The Payne Firm, Inc.
Environmental Consultants

November 22, 2004

Reference: South Dayton Dump and Landfill
Proposed National Priorities List (NPL) Listing
Hazard Ranking System Documentation Review
Project No. 0279.44.10

Figure 2

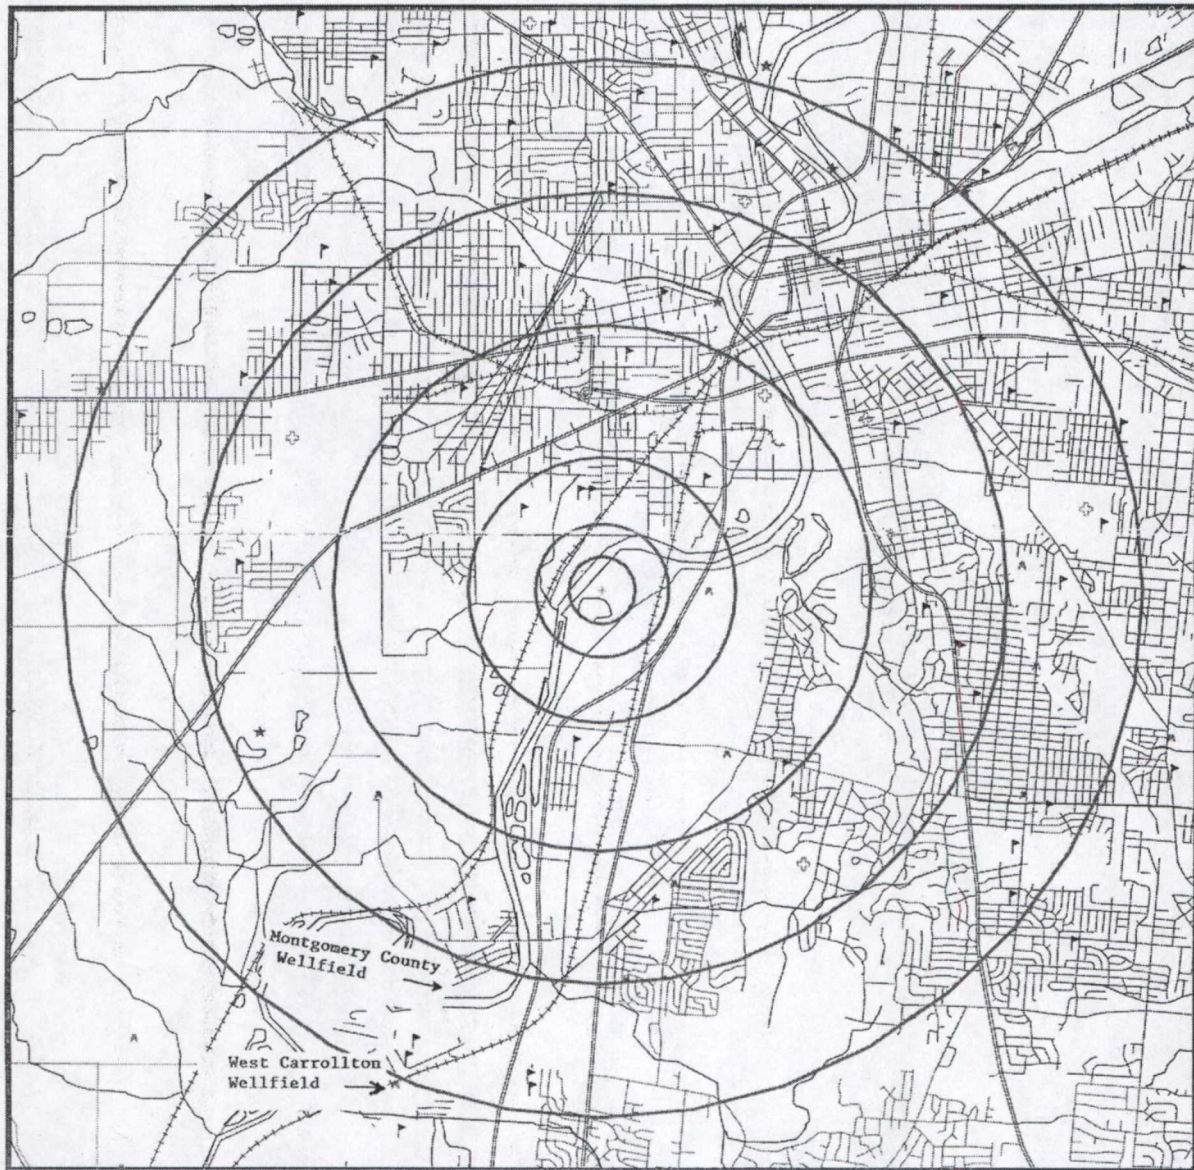
Ironically, the Ohio EPA has had the correct distances in their GIS database for some time. A map of the appropriate 4-mile radius prepared by the Ohio EPA circa 1996 is included as Figure 2. This map clearly indicates the correct radius intervals as described above. Indeed, Ohio EPA's own STEP report indicated, in pertinent part, that the West Carrollton wellfield is "located just over four miles southwest of the site."¹⁹

Figure A-2
Conceptual Cross Sectional Profile Parallel to Buried Valley
 Miamisburg/West Carrollton Wellhead Protection

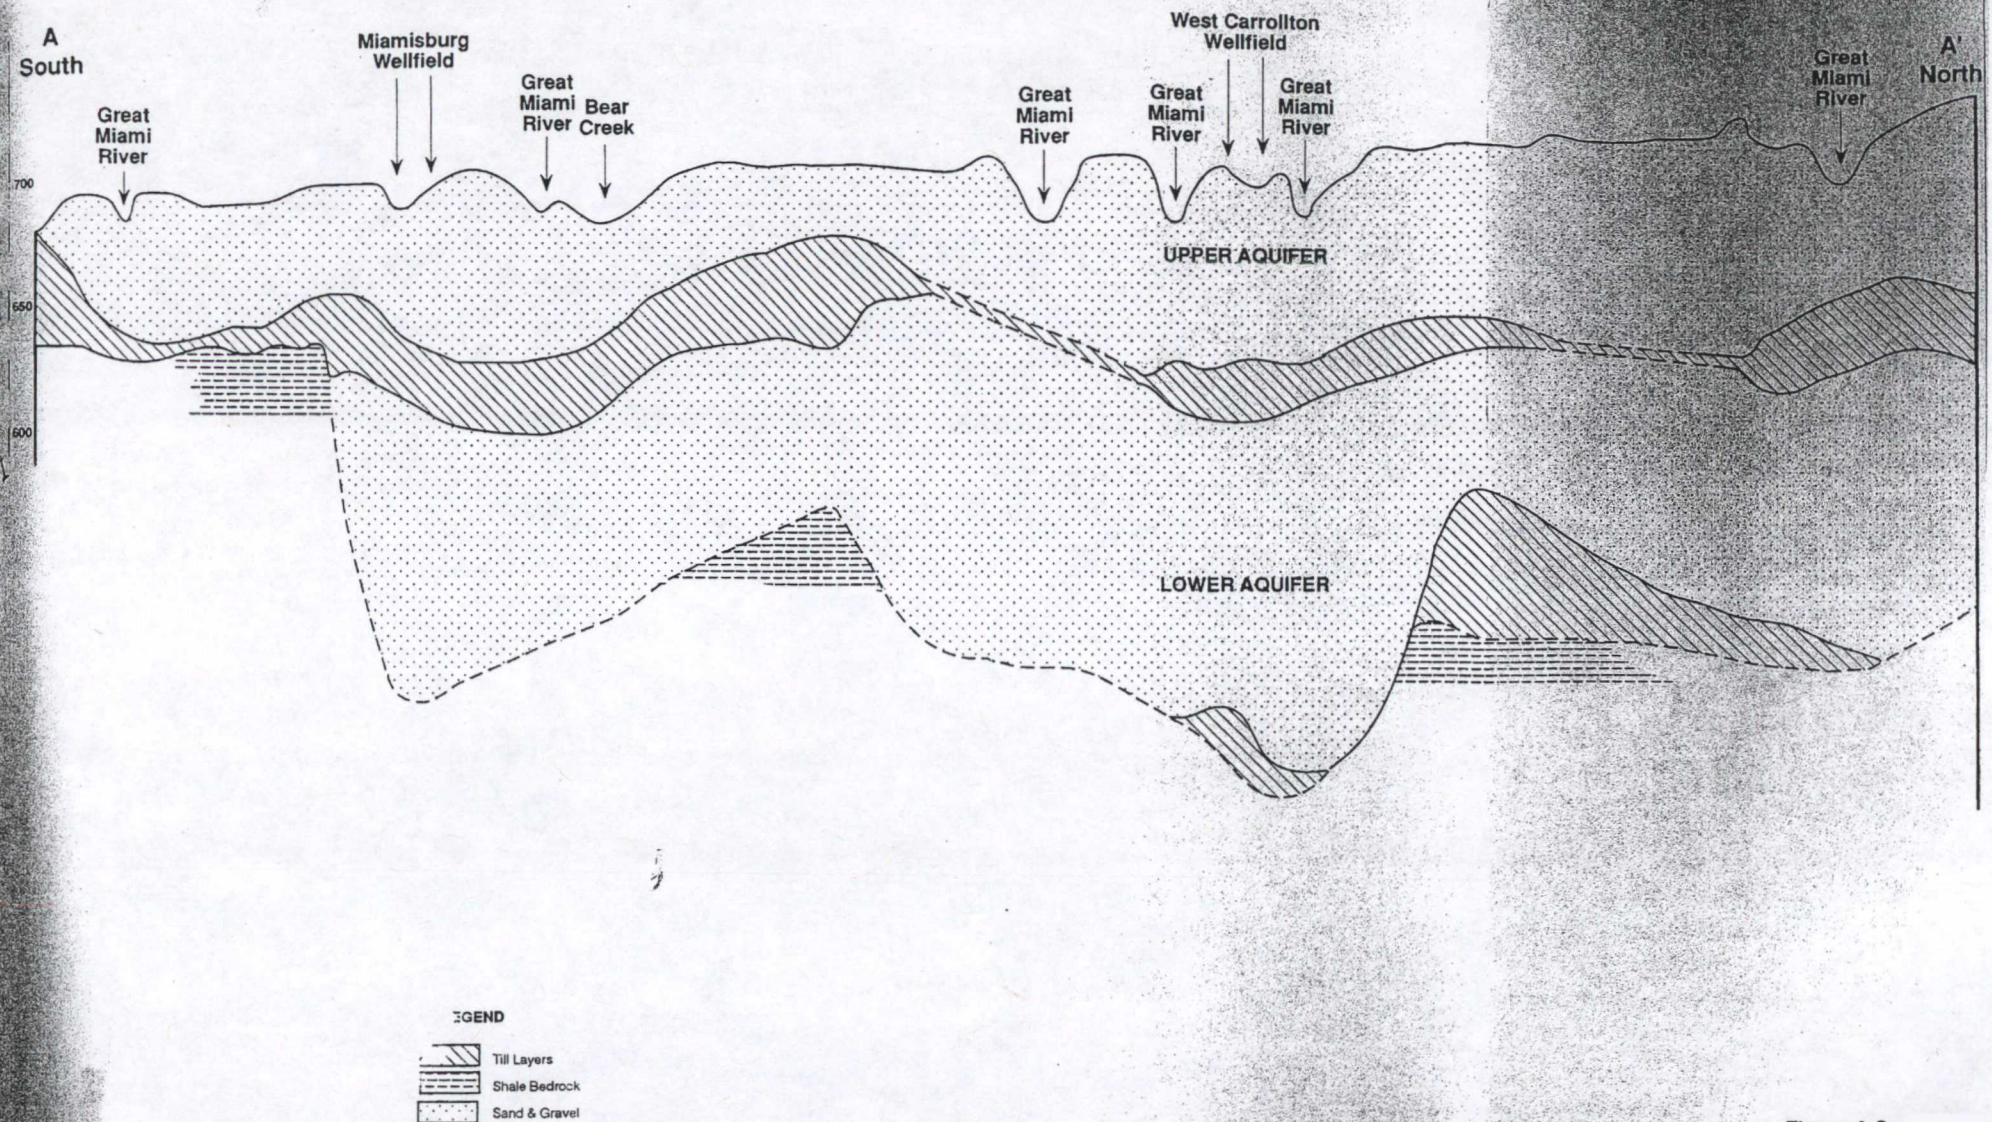
- The USGS *Ground Water Resources of Dayton Area, Ohio* shows the till zone at the nearby Dayton Power & Light facility and discusses its apparent variability and effectiveness.¹⁵
- Since the upper aquifer has been the focus of past investigations at the SDL site, most of the wells installed at the site are not deep enough to have encountered the till zone. However, in the few wells that are sufficiently deep, till was encountered in the borings.¹⁶
- The Ohio EPA-approved Well Head Protection Plan for the City of West Carrollton contains cross-sections indicating that the till layer is continuous within the well head protection area which extends over four miles from the SDL site. (See Attachment 2.)
